Objections to
Environment Agency environmental permit application
EPR/BB3300XG/V007
(Horse Hill Developments Ltd at Horse Hill RH6 0RB)

David Smythe
(Emeritus Professor of Geophysics, University of Glasgow)

15 May 2021

Fig. 8

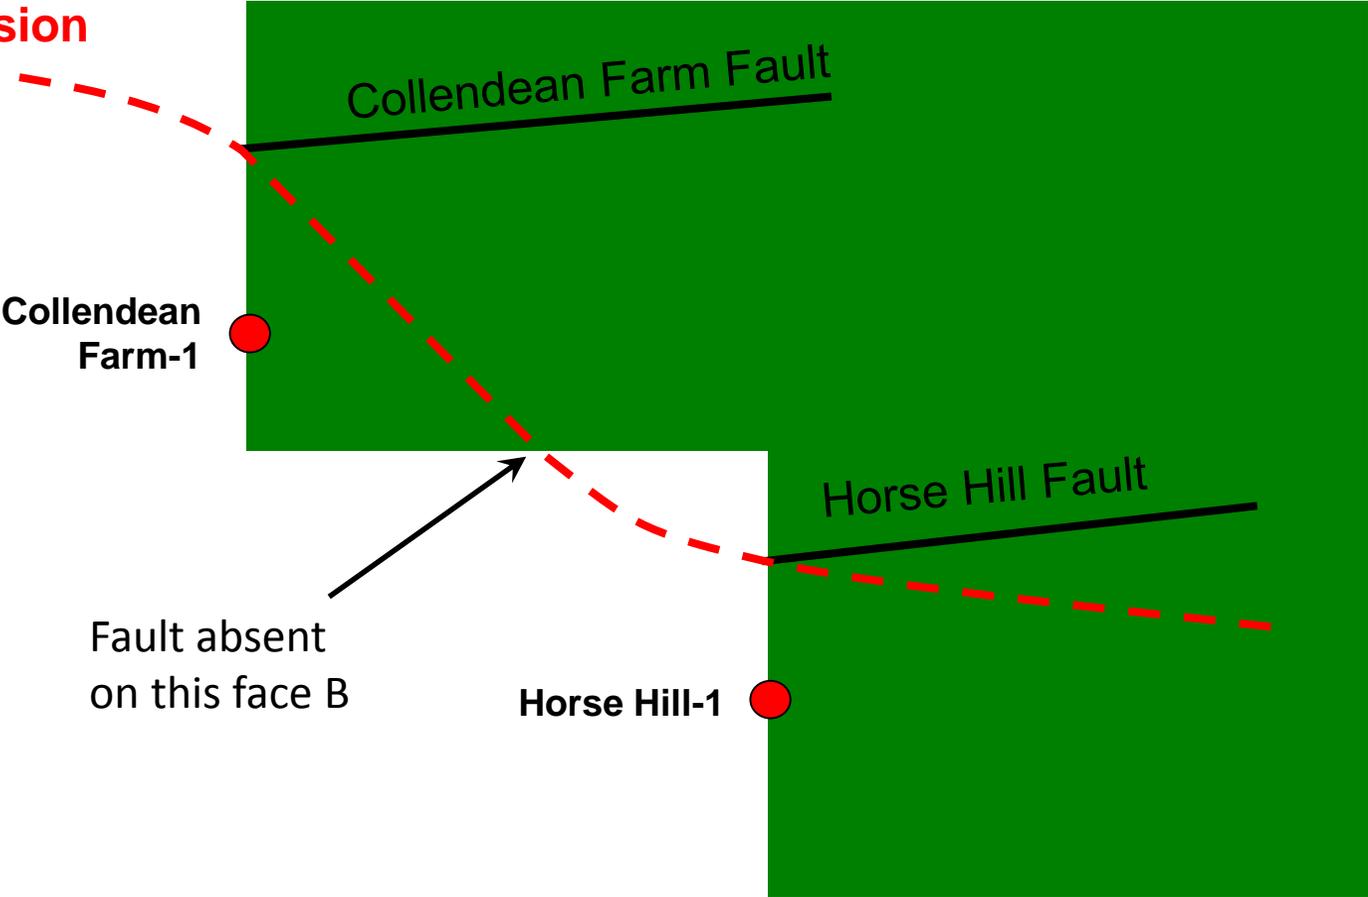
**HHDL
Single fault
version**

Plan view of Figure 7, demonstrating that the HHDL single fault version (red dashed line) is internally inconsistent, even though CF-1 is now correctly positioned on the south side of the Collendean Farm Fault.

ES Figure 5: Proposed Development at Horse Hill Well Site¹²

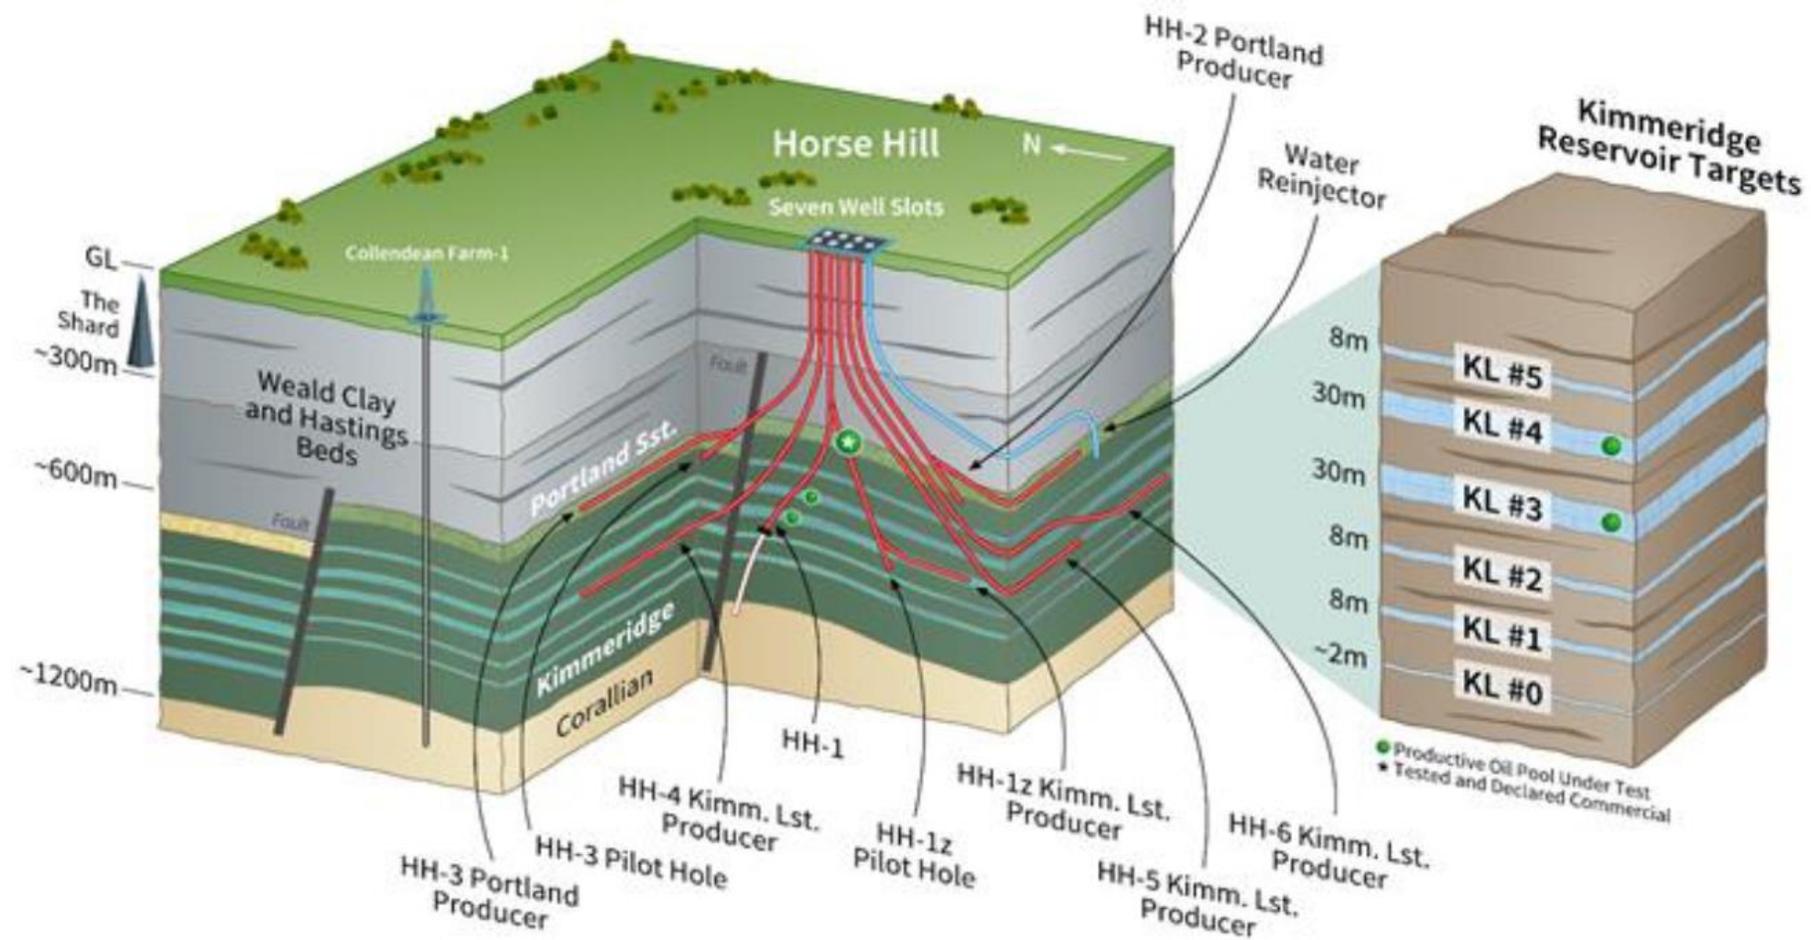
The second cartoon submitted by HHDL shows the proposed developments, as of 2019 (Figure 9). Note that the vertical faces of the 3D perspective view are aligned E-W or N-S. So the wells depicted on these faces deviate in the same two directions. HH-2 and HH-2z, which have since been drilled, are labelled as the 'HH-2 Portland Producer'. It is now desired to convert HH-2z into a water reinjector, to replace the proposed injection well shown in light blue in Figure 9. This well is discussed below.

It is surprising and unacceptable that the cartoon supplied by HHDL and shown in Figure 9 is the sole basis upon which the operator was granted planning permission by Surrey County Council in 2019, and has been able to start further drilling.

Horse Hill-2z was not drilled to the south, as implied by the cartoon shown in Figure 9, but instead followed an ESE direction along seismic line BP-85-74. HHDL now wishes to convert this failed production well into an injection well. Because of the change of use, the EA has commendably asked for more details. In response to this request, HHDL has provided an interpretation along the proposed injection well to confirm the:

This cartoon grossly is insufficient in detail for a serious production planning application. But the required detail has not been submitted.

Figure 10

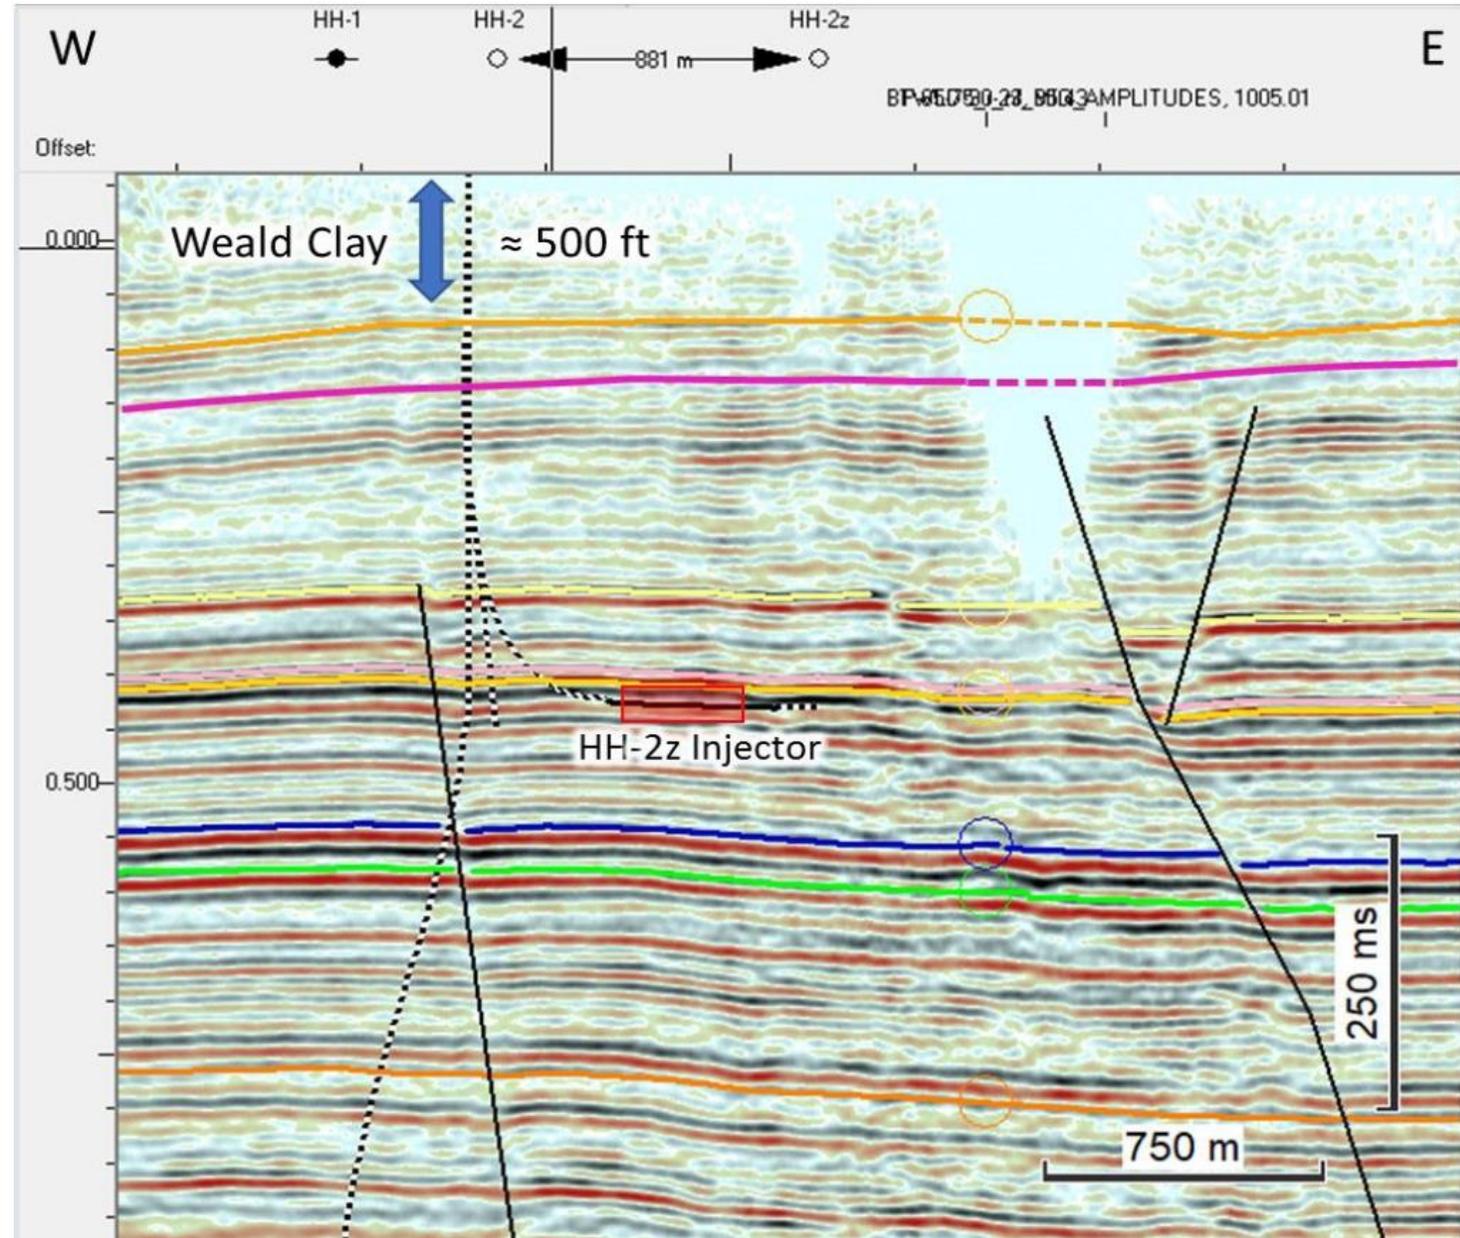
The HHDL version shows just three interpreted faults. The most westerly fault, downthrowing to the east, corresponds in part to my Brittleware Farm Fault shown in light blue in Figure 11. The other main fault on the HHDL version (Figure 10) corresponds closely to the Horley Fault, shown in orange in Figure 11. The lilac fault that I have interpreted in Figure 11 is the Ferrier’s Forge Fault. The layer offsets corresponding to this fault are clearly visible in the HHDL version of Figure 10, but HHDL has omitted to interpret a fault there. Similarly, there are eight or so additional minor faults interpreted by myself (black lines in Figure 11) which HHDL has chosen not to recognise.

The Horley Fault has a throw of 30 ms (c. 40 m) at around 200 ms TWT, corresponding to the Ashdown Sands (which lie at only 228 m subsea depth at HH-1z). It is probable that this fault extends upwards to outcrop. It is curious that the crucial shallow data are missing from the reprocessed seismic line used by HHDL in Figure 10, leaving a V-shaped gap where the fault has been partially extrapolated upwards by HHDL.

The injection zone of HH-2z is shown by the orange box within the Portland Sandstone. Three faults (black) are interpreted by HHDL.

Figure 11

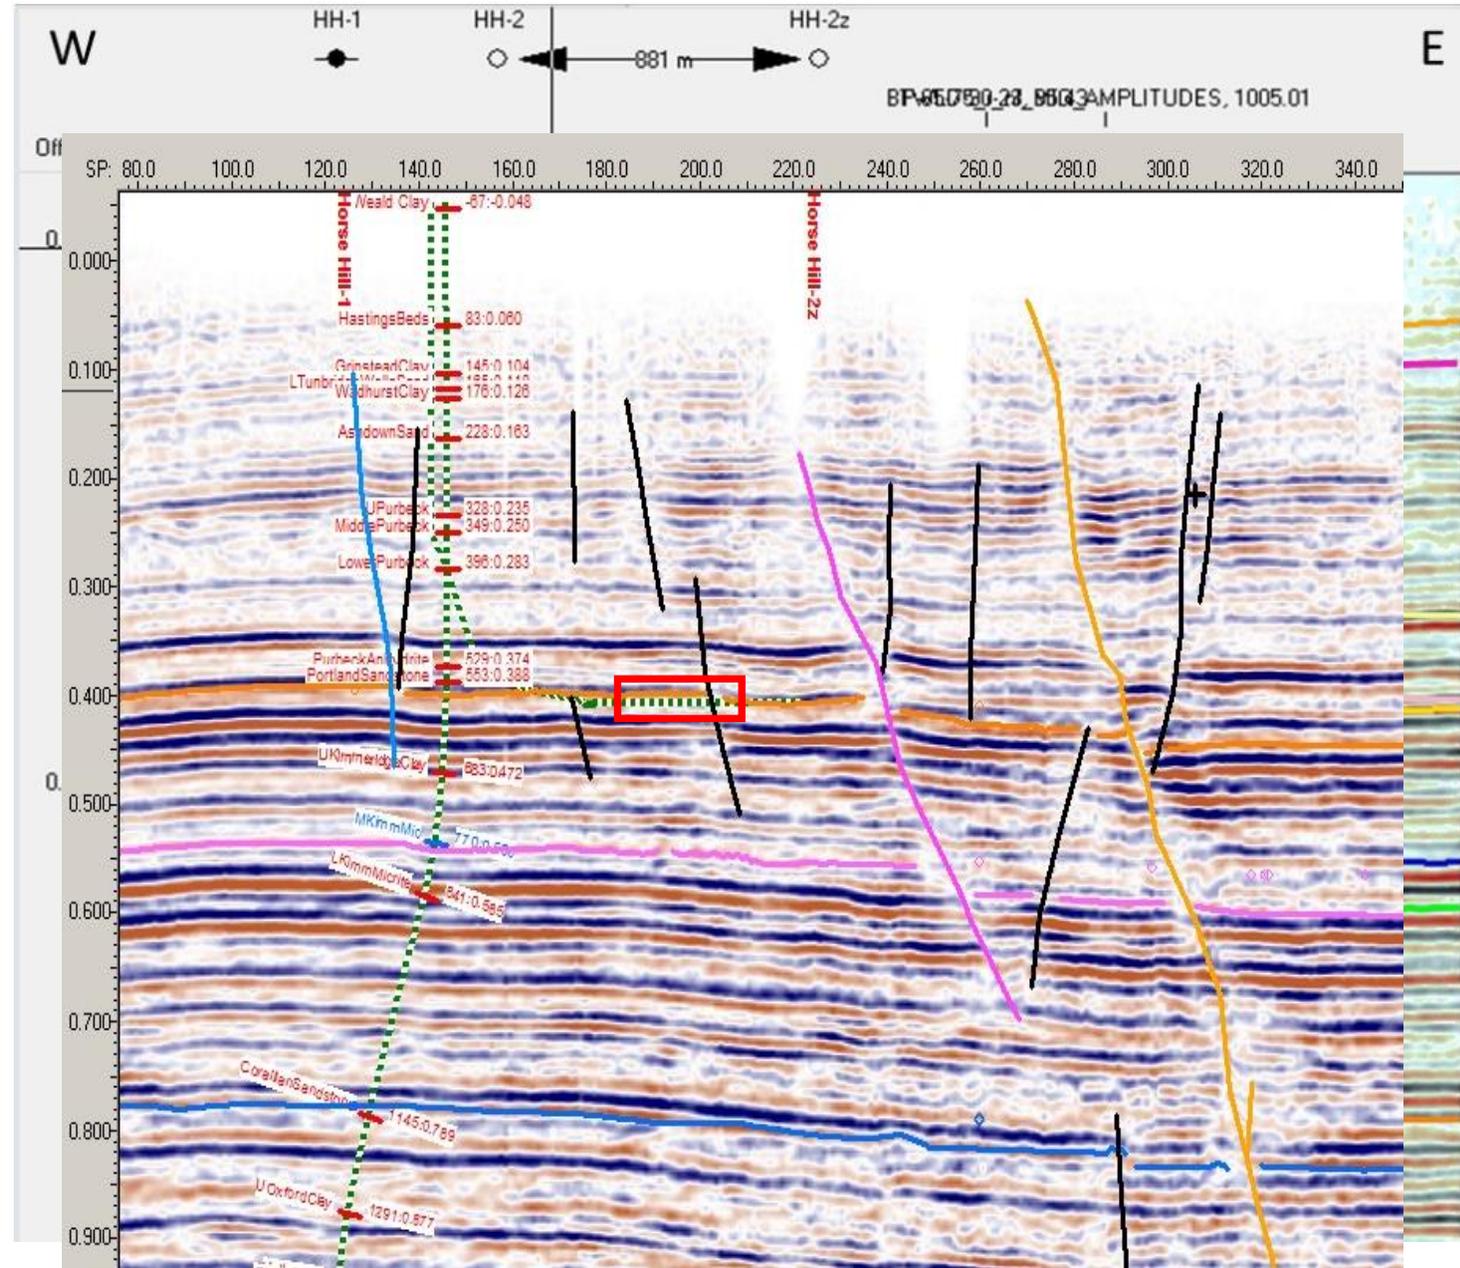
Seismic line BP-85-74_OS, as mapped and interpreted by myself. The coloured faults are:

The proposed injection zone is shown by the red rectangle

Figure 12

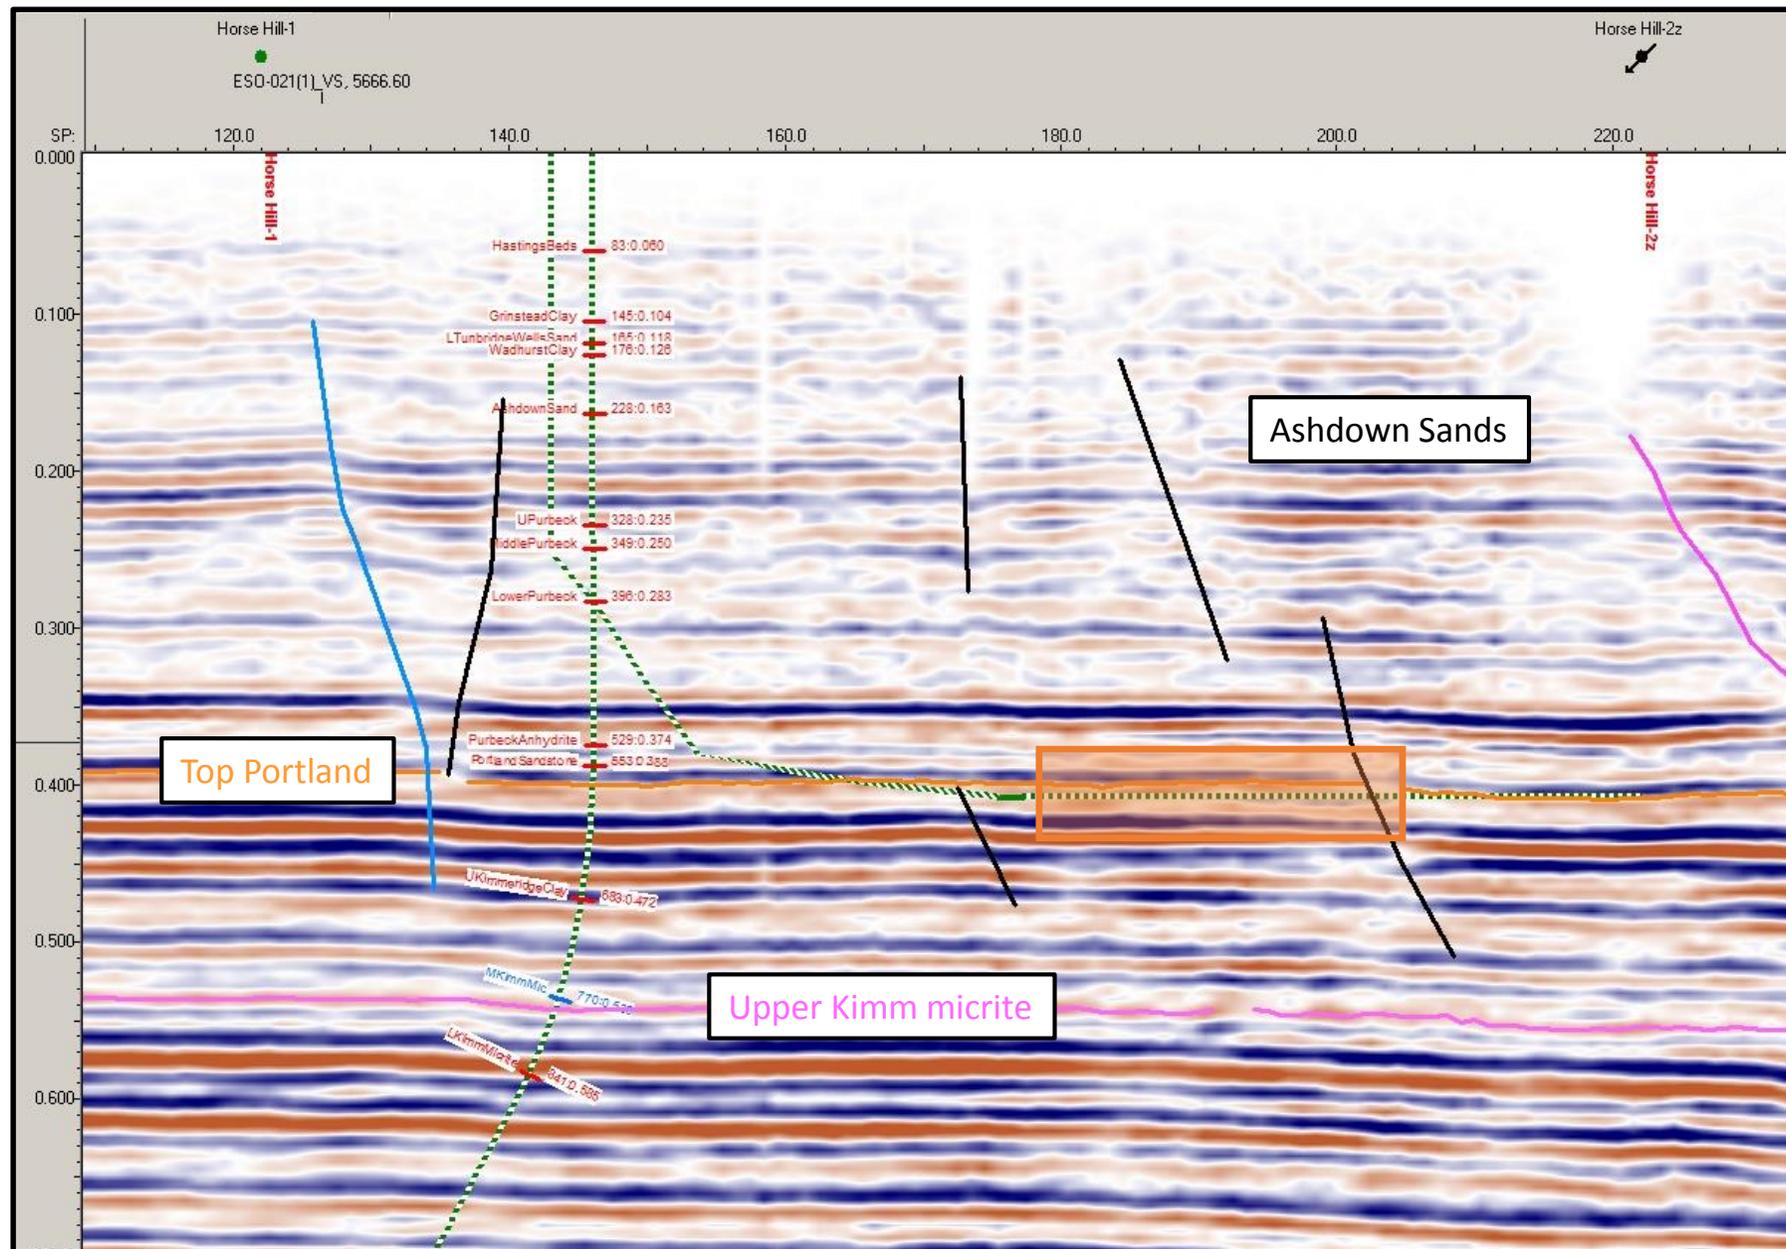
The Brittleware Farm Fault has a vertical offset of up to 10 ms (about 12 m) at Ashdown Sands level. It is shown in more detail in Figure 12. This fault (light blue) merges downwards with an adjacent fault with an opposite sense of throw, so that the net displacement becomes zero downwards, below the Portland. However the reprocessed version used by HHDL shows this fault continuing deeper. Figure 12 also shows the injection zone. At its eastern end it is cut by a fault with its vertical component having a displacement of a few metres.

Insufficient detail has been provided by HHDL to justify the existence of this fault, although it may correspond locally to my Brittleware Farm Fault (Figures 11, 12). It cannot be mapped on the adjacent seismic lines, so there is no support for inferring that this fault is a splay fault off the Horse Hill Fault. To the east, on BP-85-75, the position of HHDL’s splay fault corresponds to my Horse Hill fault (Figure 5). However, the statement demonstrates that HHDL believes that fluid injection into HH-2z can migrate *through* the fault towards HH-1. If this is the case (that the fault in question is transmissive to fluid flow), then it is equally plausible that the many shallow faults at Portland and higher levels up to outcrop (Figures 11, 12) will be equally susceptible to upward migration of injected fluids. HHDL cannot have it both ways.

Detail of BP-85-74 showing proposed injection zone

The Brittleware Farm Fault is shown in light blue. It may correspond locally to the splay fault interpreted by HHDL (Figure 4 above).
